UNITED STATES PATENT AND TRADEMARK OFFICE

APPLICATION NO.	FILING DATE	FIRST NAMED INVENTOR	ATTORNEY DOCKET NO.	CONFIRMATION NO.
09/823,162	03/30/2001	Mauro Colombo	G93-059	8115

Office Action Summary

DETAILED ACTION

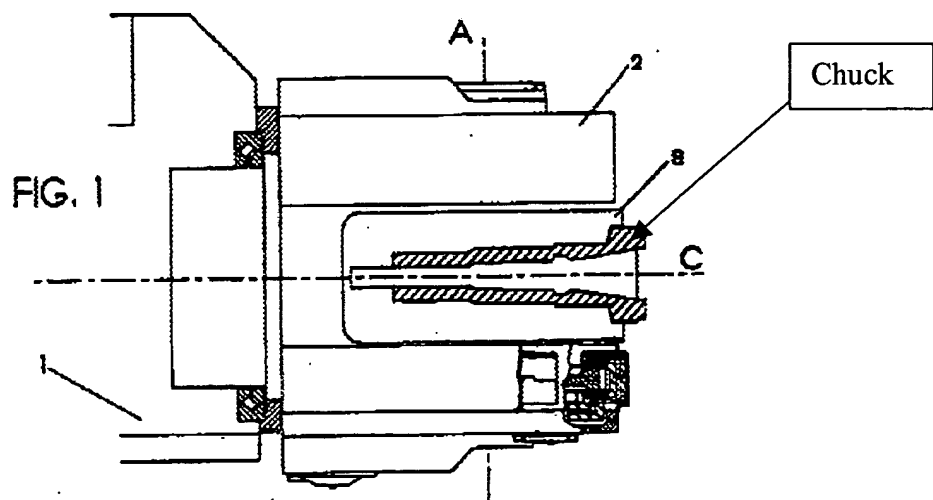
'146 teaches a "first support" 2 adapted for rotation about a "first axis" C and mounted on a structure 1 movable in a set of three Cartesian axes (Figures 1 and 3, col. 1, lines 6-40, for example). Additionally, the chuck structure labeled as "3", shown in Figures 1 and 3 is considered the "second support", and is rotatably mounted to the "first support" 2 for rotation about axis A which is orthogonal to axis C (Figures 1 and 3). Note that the chuck structure 3 has mounted therein a chuck, or tool holding device, labeled "Chuck" in the reproduction of Figure 1 below.

This "chuck" is considered to be "interchangeable" in that it is "able" to be interchanged, i.e., since it is composed of pieces that are separate or non-unitary with the rest of the chuck structure 3, it is able to be removed therefrom and replaced with another chuck. Note that the aforescribed "chuck" is shown as projecting beyond the end of the chuck structure 3 in Figure

1. Note that the “chuck” inherently must be driven by some sort of drive (and thus it must inherently be “coupled” to such a drive) in order for a tool held thereby to be able to rotate about its own axis and thereby machine a workpiece. Alternatively note that the chuck structure 3 (and the “chuck”) are driven about axis A via a drive motor and gear which are coupled to a cogwheel 4 that is integral with the chuck structure 3 (col. 2, lines 24-34), and which is thus “connected to” the “chuck” of the chuck structure 3. Note that this drive motor and gear system thus “control” the rotation of the “second support” 3 about axis A. Additionally, ‘146 teaches a device for selectively locking the “second support” 3 in a desired orientation about axis A, which locking device includes pads 5 that are pressed against the sides of cogwheel 4 via hydraulic fluid to “frictionally” lock the “second support” (col. 2, lines 35-47 and 58-64, for example).
